# MATANUSKA-SUSITNA BOROUGH PLATTING BOARD AGENDA

**OCTOBER 15, 2020  
 REGULAR MEETING  
 1:00 P.M.**

PRELIMINARY PLAT: SUSLOSITNA PLACE MASTER PLAN  
LEGAL DESCRIPTION: SEC 21, T18N, R01W, SEWARD MERIDIAN AK  
PETITIONERS: IGOR & NATALIYA ZHUCHKOV  
SURVEYOR/ENGINEER: HANSON LAND SOLUTIONS  
ACRES: 80.17± PARCELS: 70  
REVIEWED BY: AMY OTTO-BUCHANAN CASE #: 2020-100

WASILLA, ALASKA  
SUSLOSTINA PLACE  
SITE PLAN - DESIGN  
GRADING-DRAINAGE PLAN

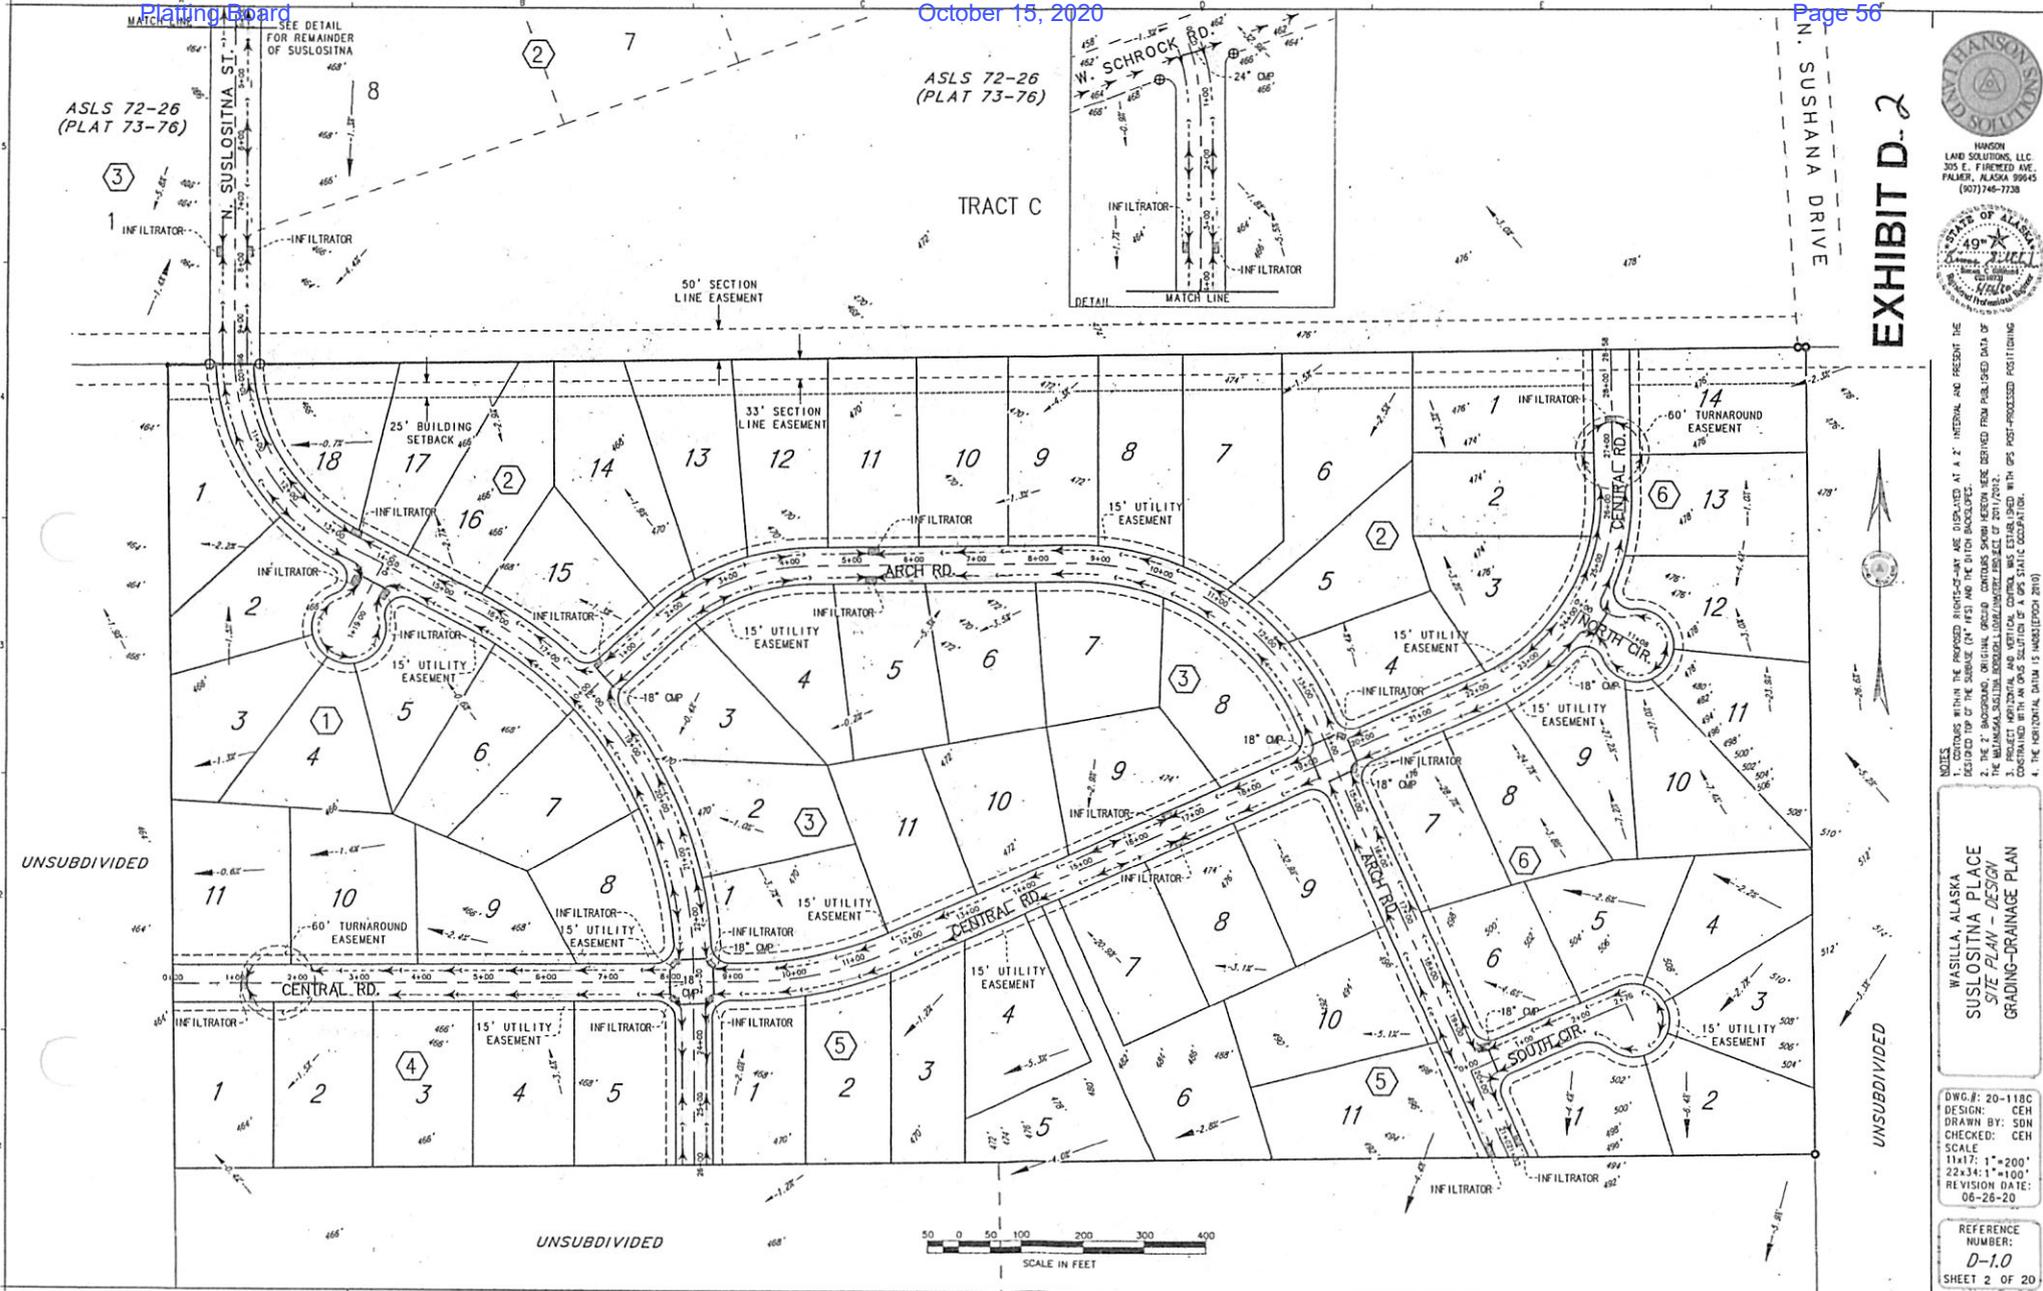
- Construct Suslositna Street, Central Road, and streets that stub to adjoining properties to Residential Subcollector standard.
- Drainage Plan:
  - Place cross culverts outside of curve returns – requires less culvert and reduces likelihood of culvert ends being crushed
  - Probably only need 2 cross culverts at 4-way intersections
  - May need drainage easements where runoff will leave the roadside ditches
- If there is any potential for commercial use of any of the proposed lots, it is recommended that Sushana Drive be constructed to provide a second access as required by International Fire Code.

WASILLA, ALASKA  
 SUSLOSTINA PLACE  
 PLAN AND PROFILE - DESIGN  
 CENTRAL ROAD

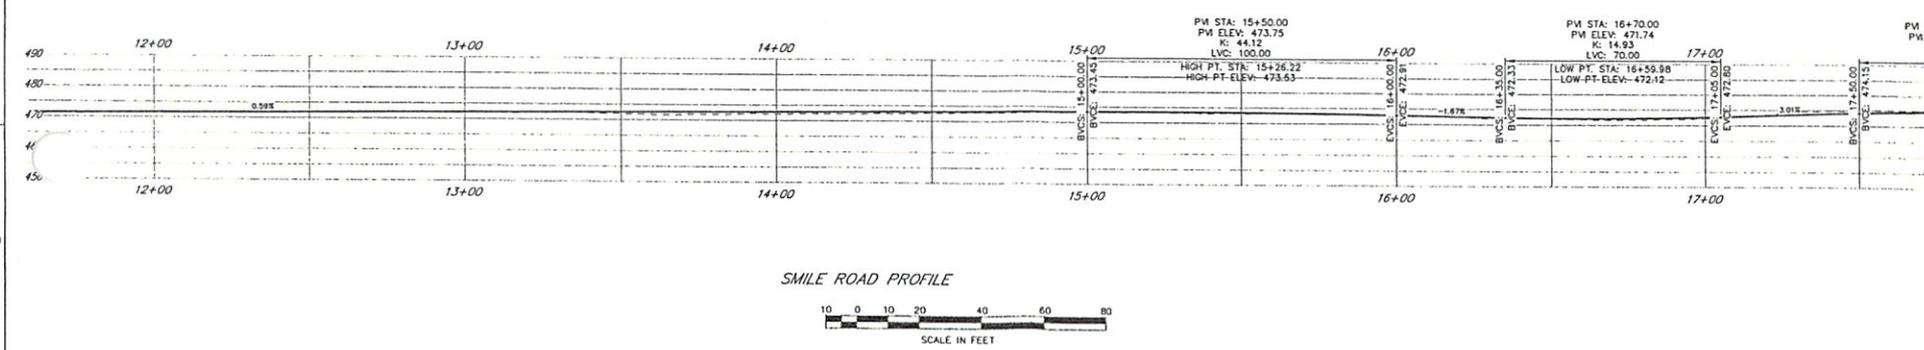
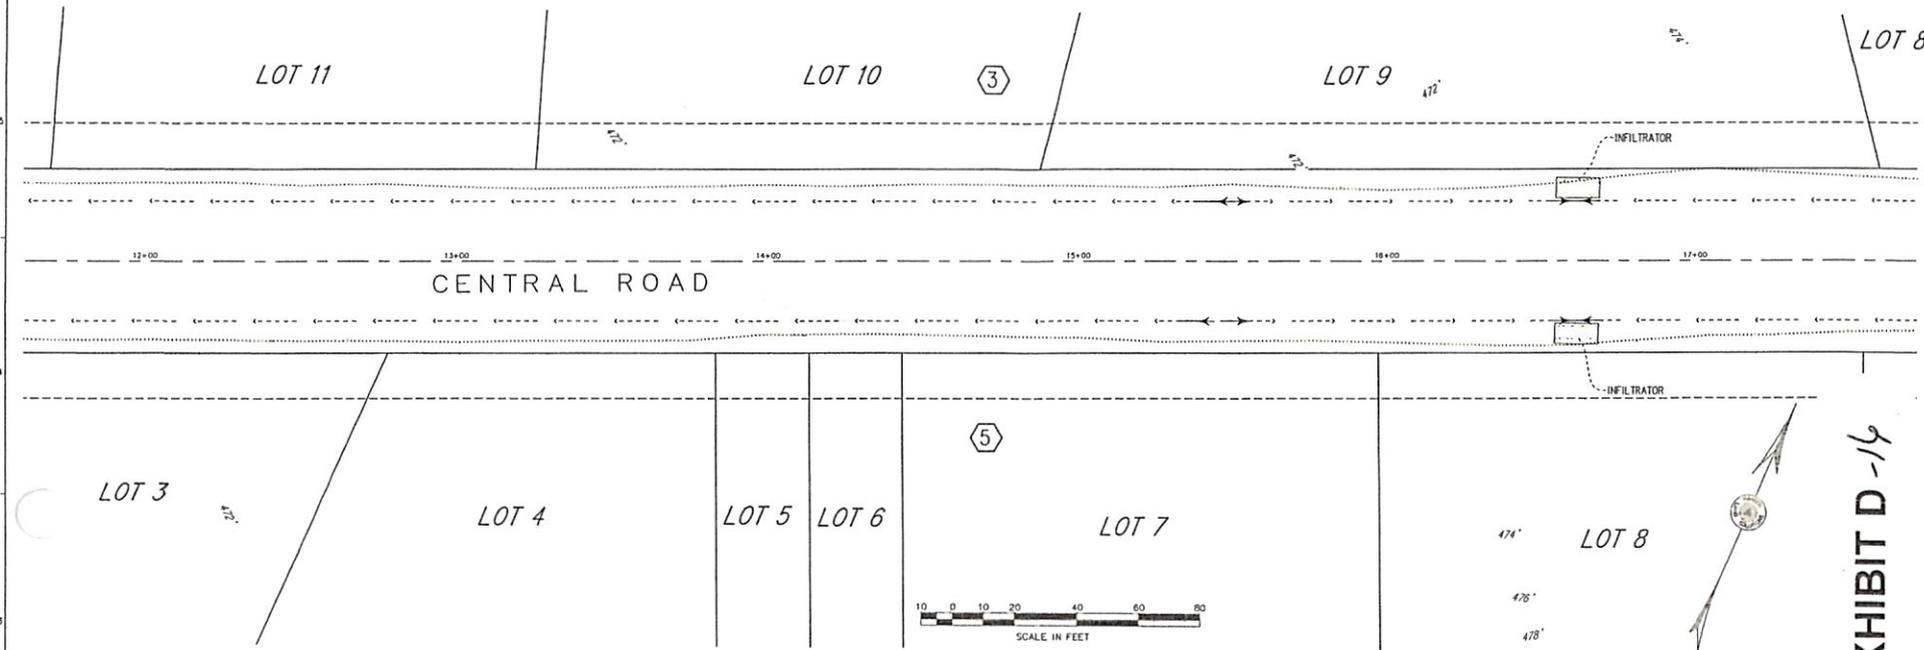
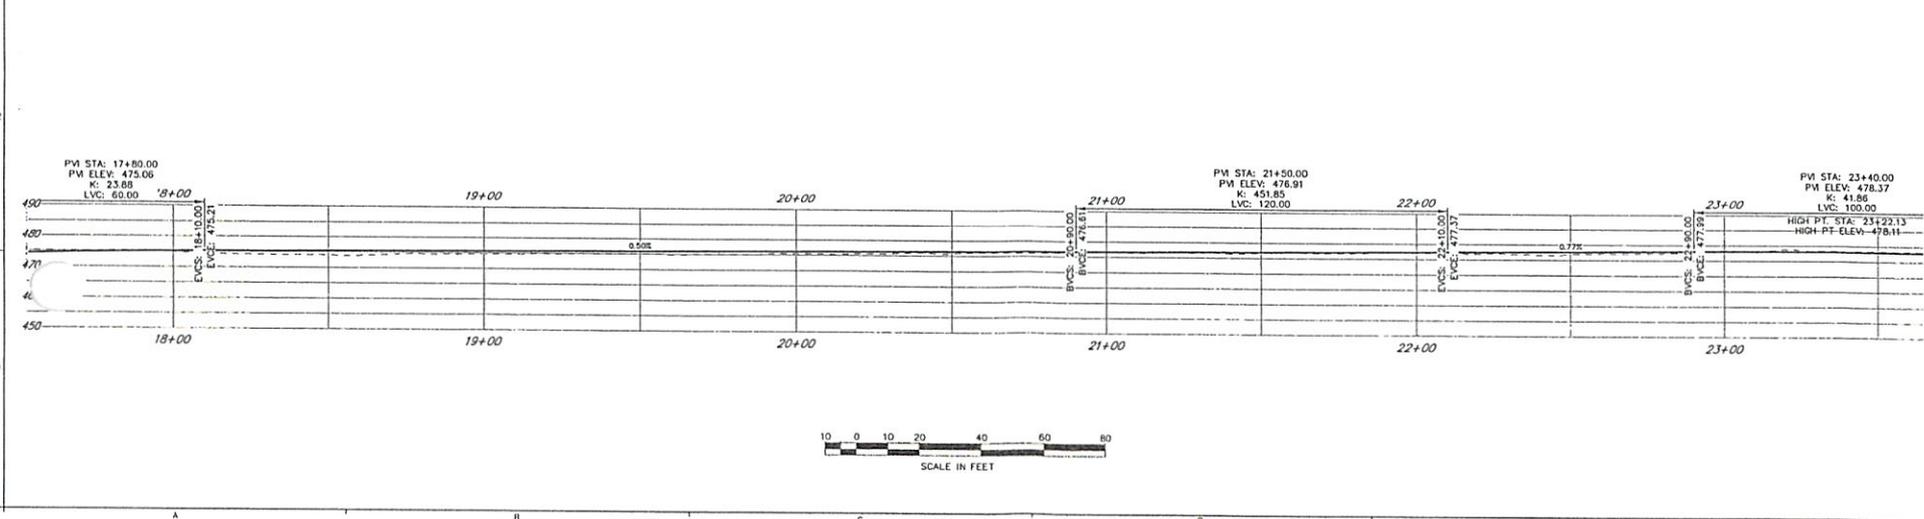
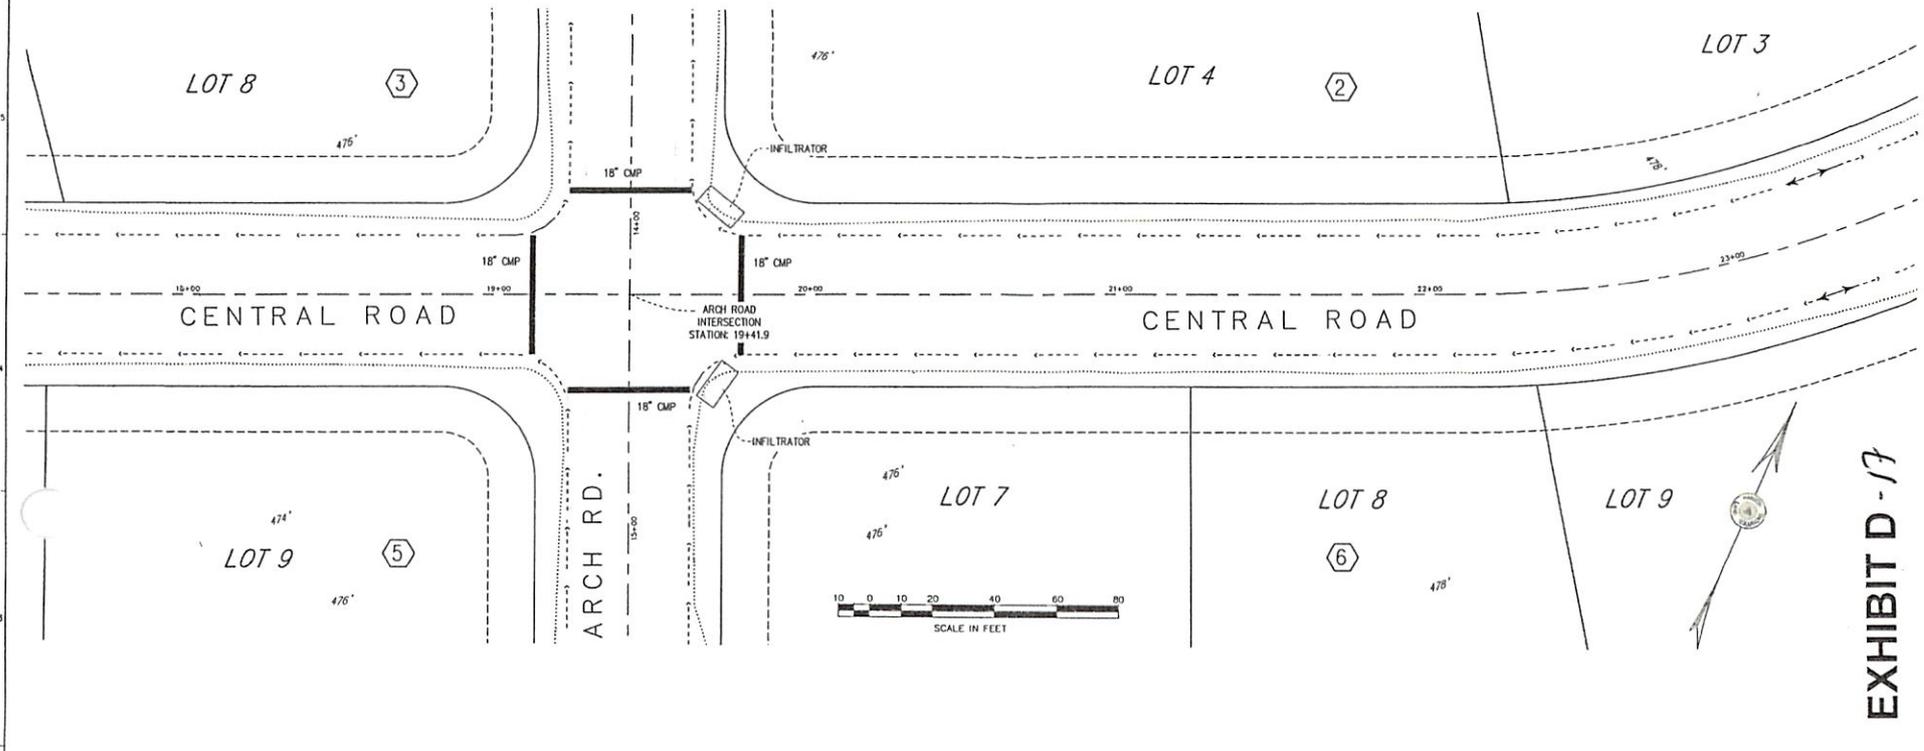
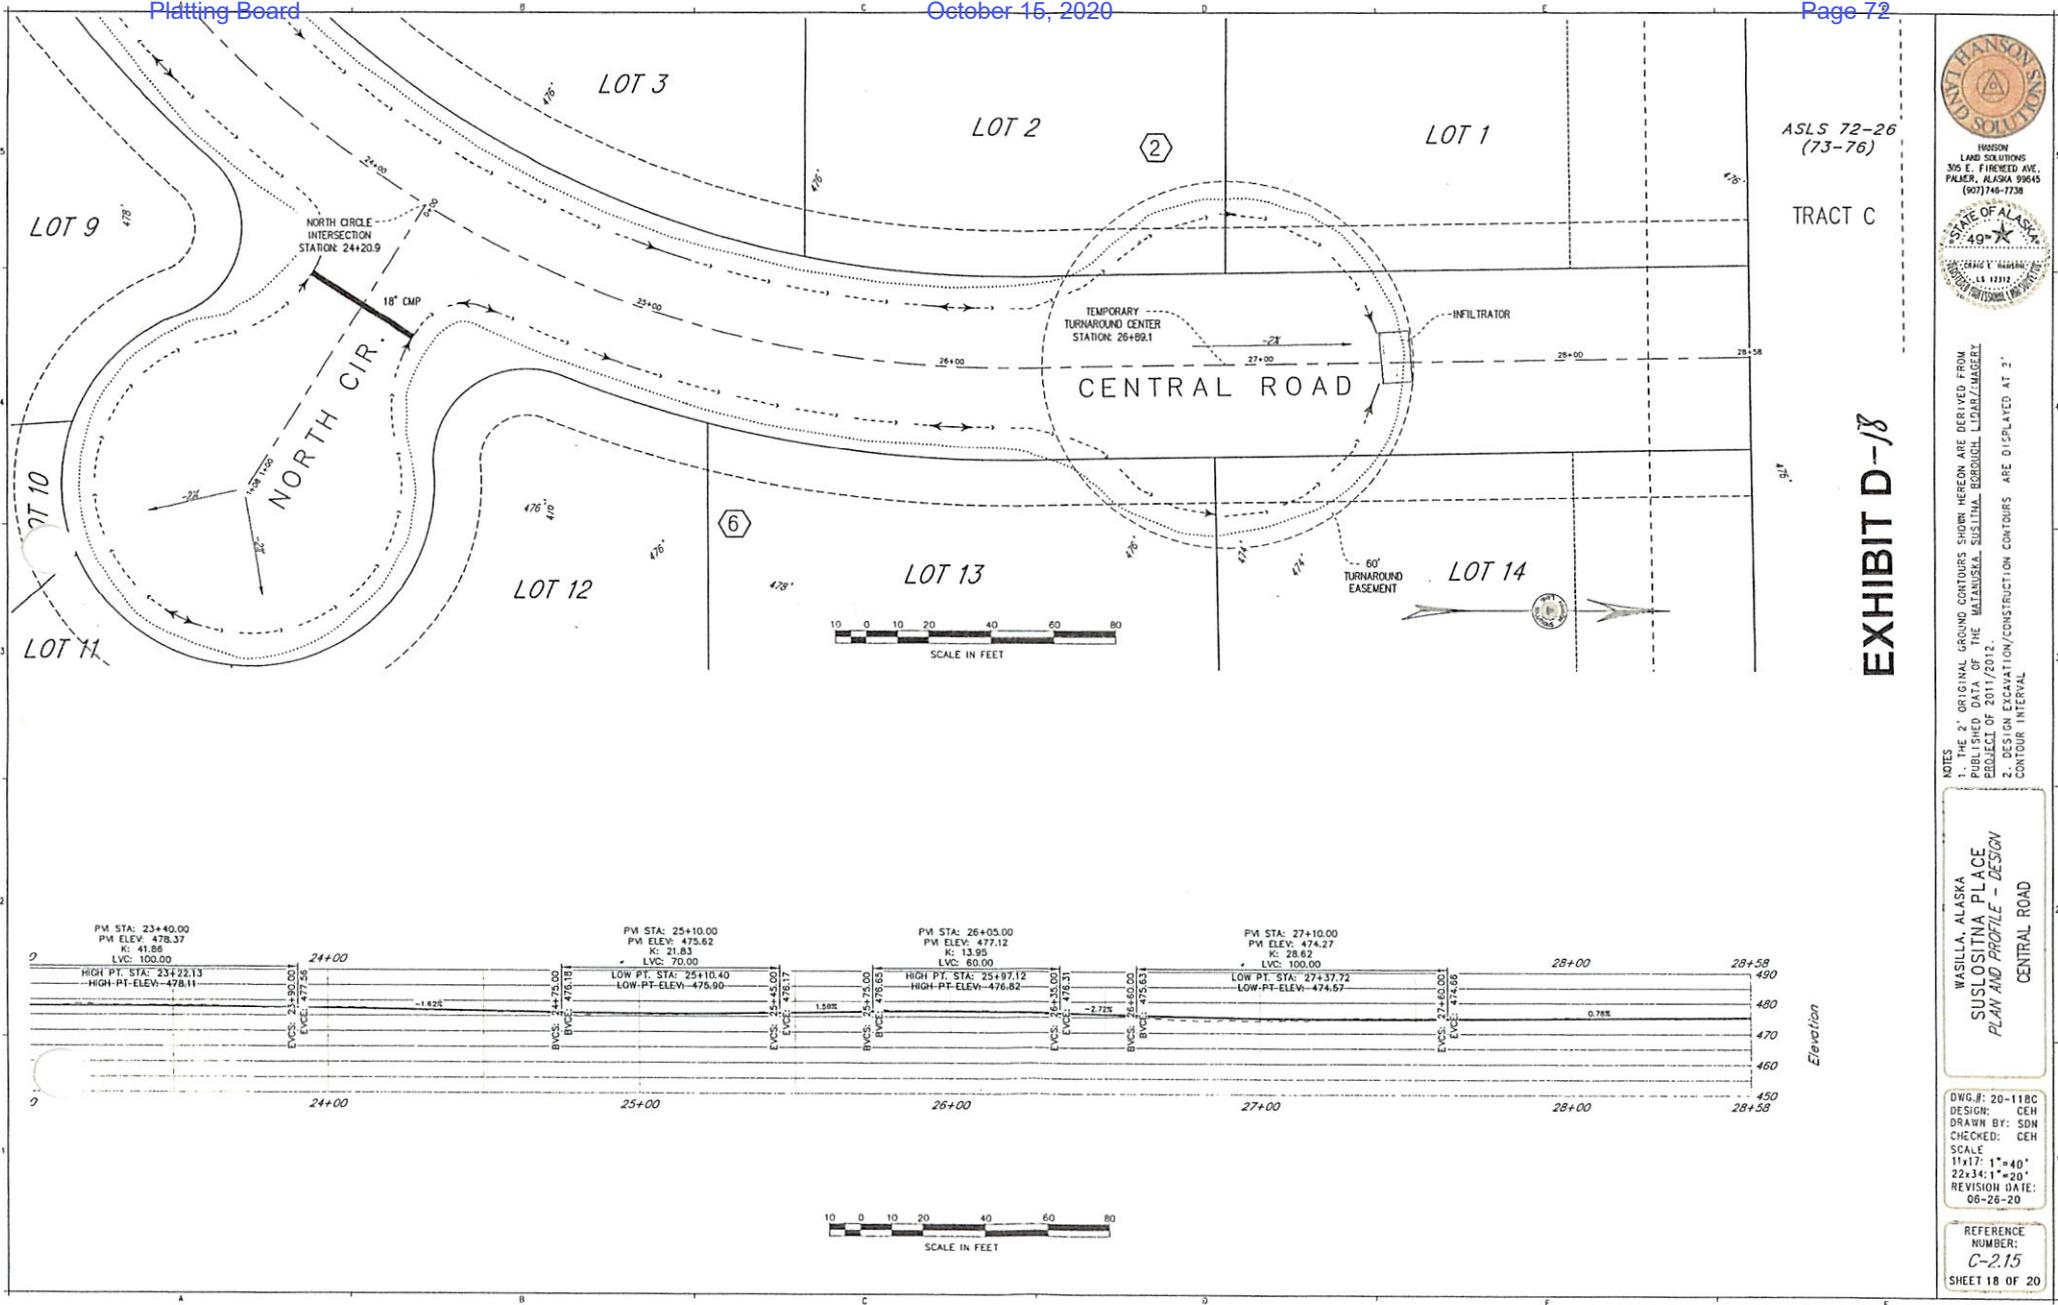
Department of Emergency Services Fire Code (**Exhibit F**) notes the plat doesn't show how W. Central Road will connect to create a second access into the subdivision.

The plat doesn't show Central Road will connect to create a second access into the subdivision.

Because of this change in circumstance, the petitioners are now agreeable to constructing the second access as requested, as the Master Plan is developed and construction becomes necessary for the fulfillment of code.
